Road Safety Audit Stage 1 Kirdford Road, Wisborough Green Site Access

Reference: RSC/MG/KS/13018/Wisborough Green

Report Title
 Road Safety Audit Stage 1

APPENDIX 2 Drawings showing Problem Locations

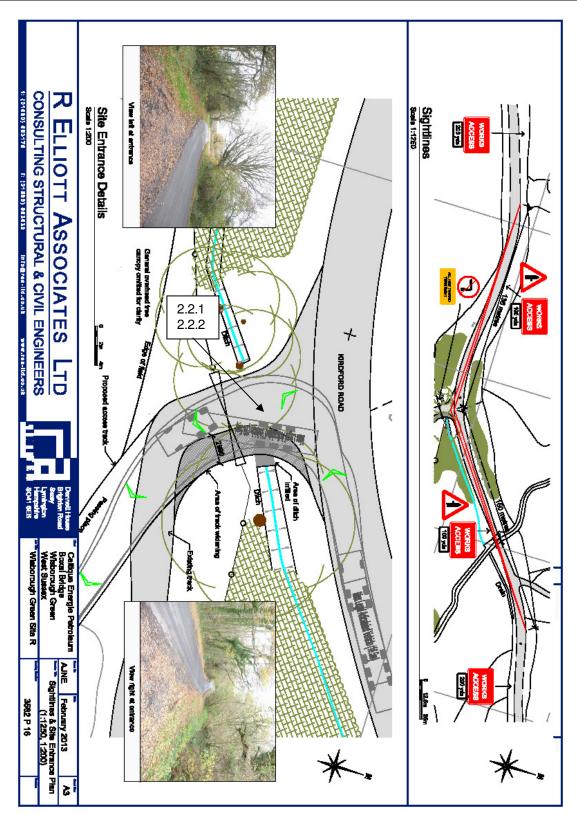
2.2.1 Problem

Location: At the site access

Summary: Conflict between large vehicles on entry and exit

There is some concern that large vehicles may arrive to enter the access at the same time as another is exiting. A large vehicle stopping unexpectedly mid-turn could result in rear end shunt type collisions.

2.2.2 PROBLEM

Location: At the site access

Summary: Detritus on the carriageway

Large vehicles leaving a site can carry mud and other detritus onto the carriageway. This could result in single vehicle loss-of-control type collisions. Riders of two-wheeled vehicles are particularly vulnerable.

It should be ensured that the arrival and departure of large vehicles at the access do not coincide.

The entry area and an appropriate length of the access road should be hard surfaced. It may also be necessary to provide on-site wheel cleaning.
